REQUEST FOR COUNCIL ACTION

AGENDA SECTION: PUBLIC HEARINGS	ORIGINATING DEPT: PLANNING	ITEM NO. E-7
ITEM DESCRIPTION: General Development Plan #200 by Todd Ustby to be known as Viola Hills Subdivision. The Applicant is proposing to develop approximately 12 acres of land located west of Osjor Estates, east of Schaeffer Lane and north of Viola Road (CR 2) with single family homes and townhomes. The property is proposed to be served by a public road, with two cul-de-sacs. An Annexation petition for the entire property, and a Zoning District Amendment for a portion of this property are being considered concurrent with this petition.		PREPARED BY: Mitzi A. Baker, Senior Planner
<p>March 10, 2003</p> <p><u>City Planning and Zoning Commission Recommendation:</u></p> <p>The Planning and Zoning Commission held a public hearing on this item on February 26, 2003.</p> <p>Mr. Haeussinger moved to recommend approval of General Development Plan #200 by Todd Ustby to be known as Viola Hills Subdivision with the staff-recommended findings and conditions. Mr. Quinn seconded the motion. The motion carried 7-0. The commission recommended the following conditions/modifications:</p> <ol style="list-styl

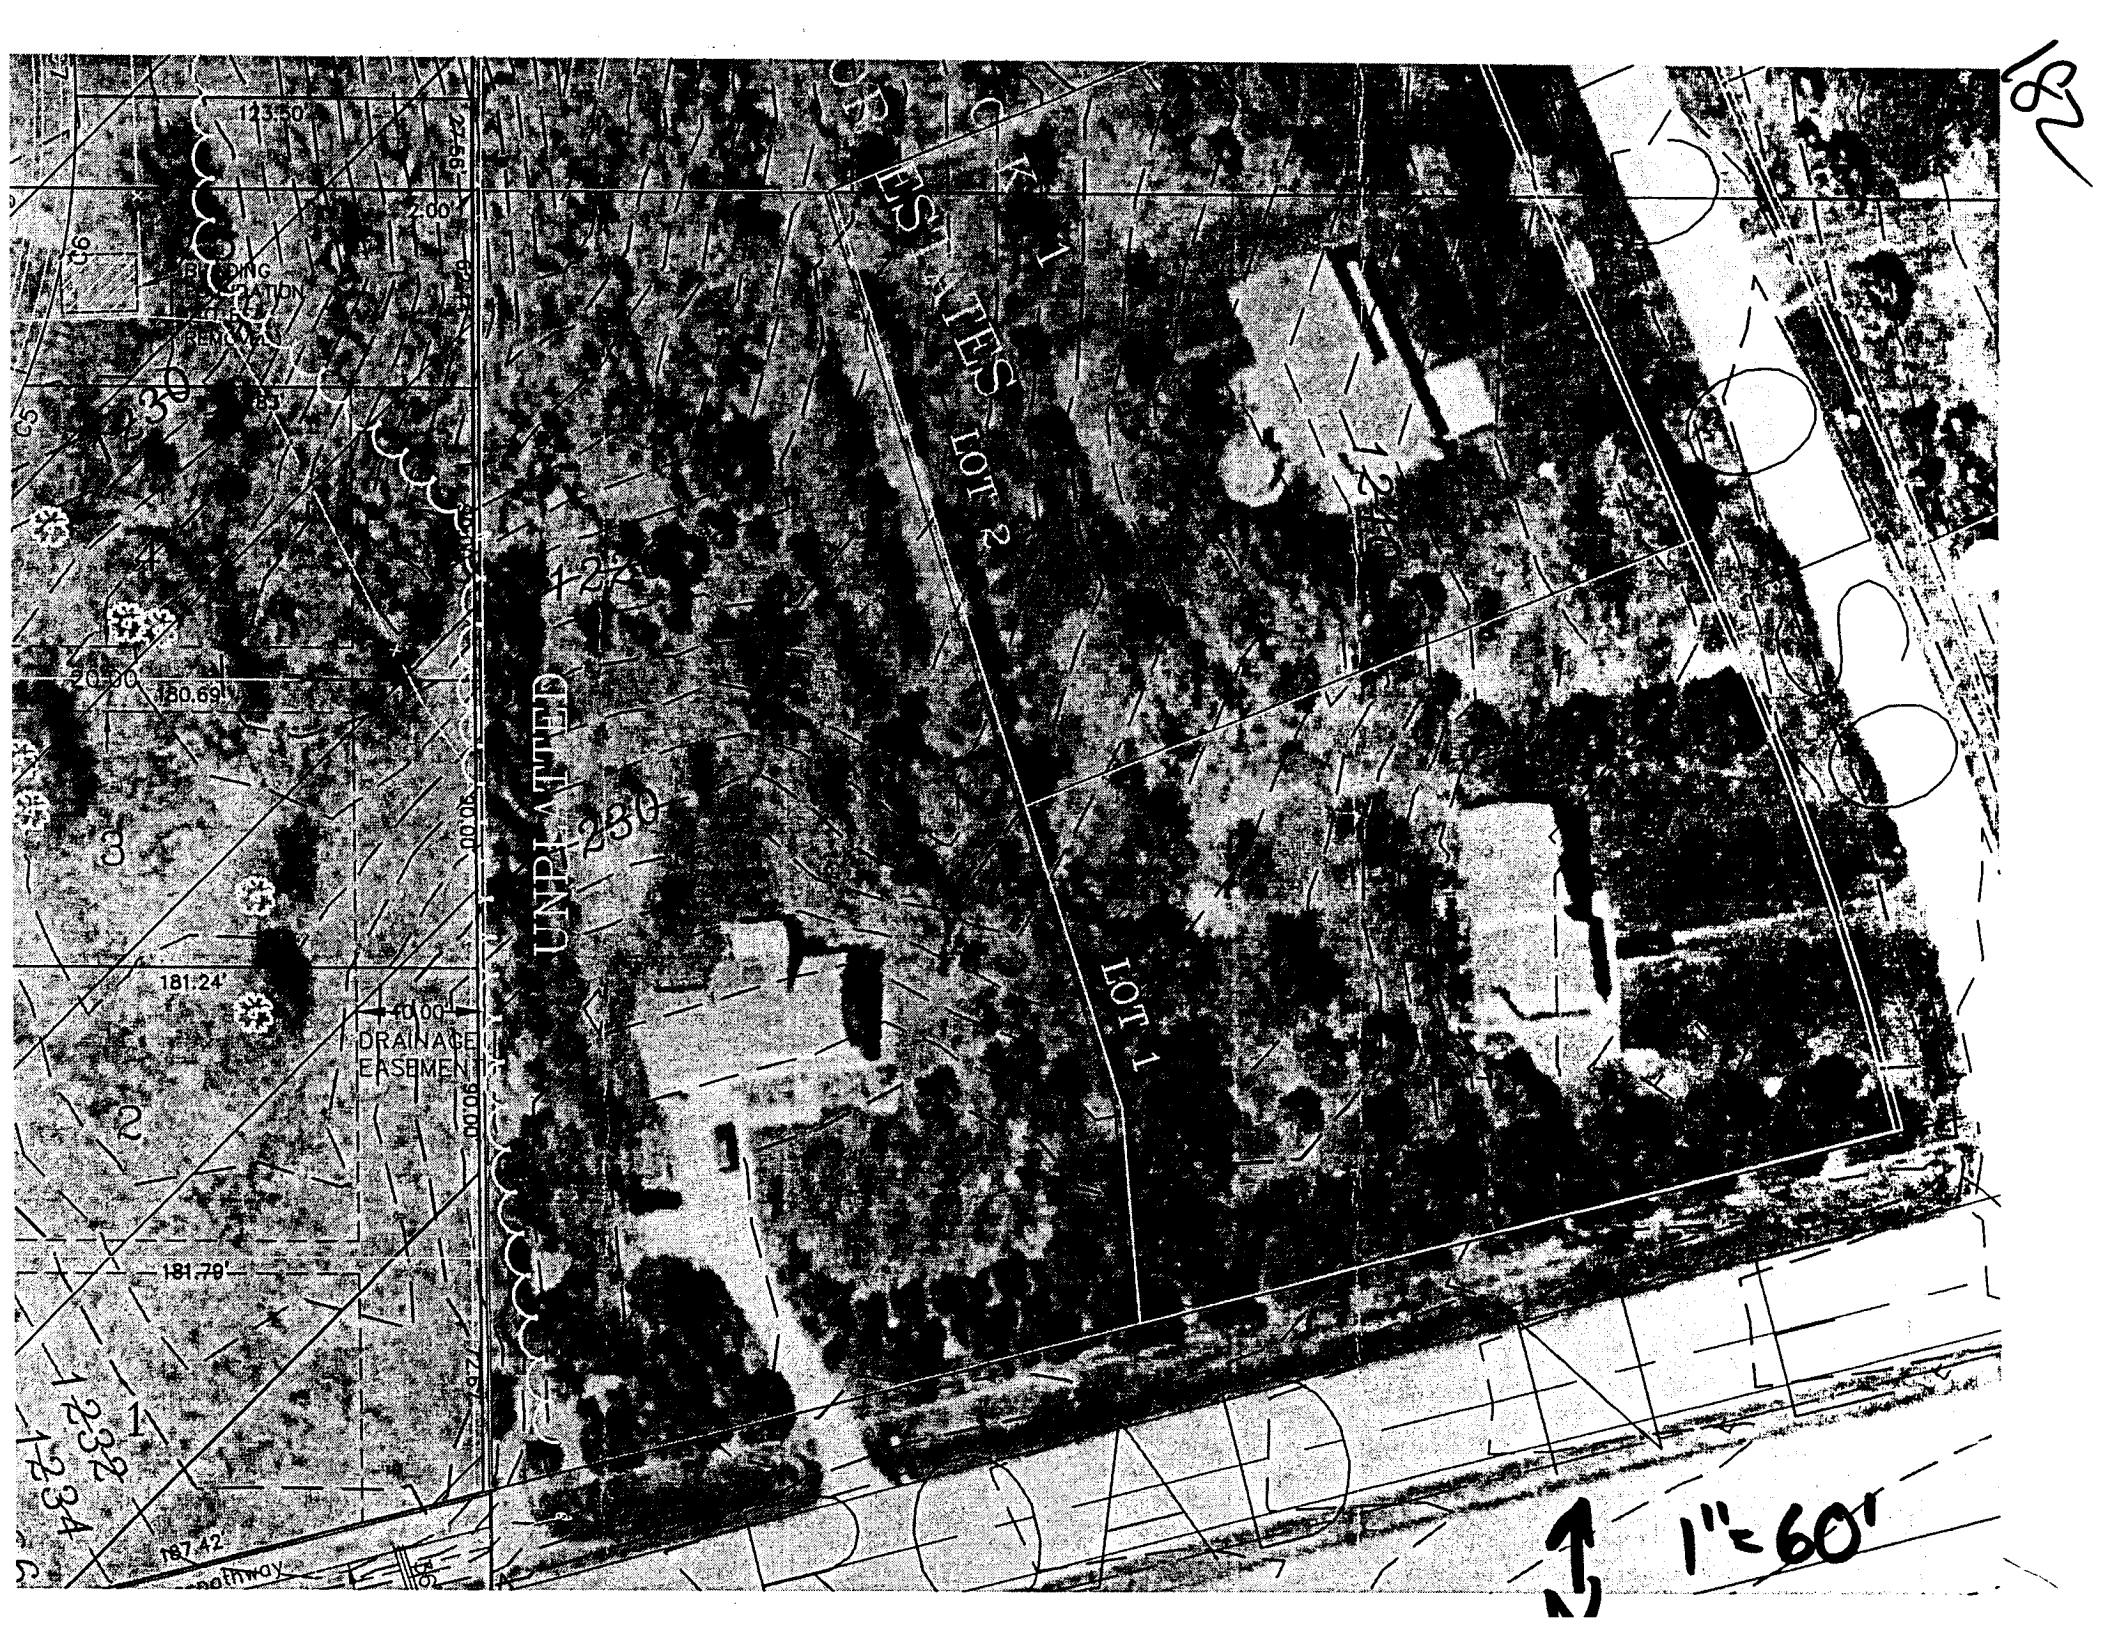
Request to provide access to the east for future subdivision via public road right of way or a permanent access easement.

This is a request that we feel don't feel falls under the responsibilities of the developer. A closer look at the property to the east may explain our position: *(Attached is a drawing showing the property with contours to show the house and grades around the property.)* The parcel to the east contains approximately 1.45 acres of property outside the CR#2 right of way. There is currently one house (in very good condition) on the property. The back of this house is approximately in line with the extension of lots 2 and 3 on our general development plan. If you create a lot line 25 feet behind the house (minimum setback), half of the property goes to the existing house. The natural grade of the land behind this house drops at a 10% to 12% grade to the north property line.

The parcel just isn't large enough or flat enough to develop as it sits. If we were required to provide access, the most lots that could be created would be three and that would be at great cost and totally ruin the value of the existing house. Additionally, the property falls off substantially so that it could not be sewered without a lift station itself. The lots created probably wouldn't cover the costs of the necessary improvements and definitely would be well below the value of the lots in Osjor Estates, Shannon Oaks or Viola Hills Subdivision. If this request is being made to remove the existing driveway onto CR#2, then additional right of way needs to be purchased for the reconstruction of CR#2 and a driveway constructed fronting the right of way. This scenario would not be relative to our general development plan but we would work with the parties involved should this be needed. Please review your request and substantiate the need to supply an access for the adjoining property to the east.

Request that development of the property be concurrent with, and/or following improvements to CR#2 to correct substandard sight distance.

We would like to propose a temporary access at the southwest corner of the property. This would alleviate any current sight distance concerns and allow development prior to the County's reconstruction project. This could also provide a secondary access during the reconstruction of CR#2. If at all possible, we would like to explore the option of participating with the county in the improvements to CR#2 and construction of the bike path and turning lane. This could help lower the costs of construction for all parties and provide a better finished product. Participating with the county in the construction costs is an item that can be worked out during approval of construction plans and the development agreement. Our concern is that if CR#2 does not get construction in 2005, we would be pushed off until the road is reconstructed. We do not wish to be put in a position to have wait indefinitely.
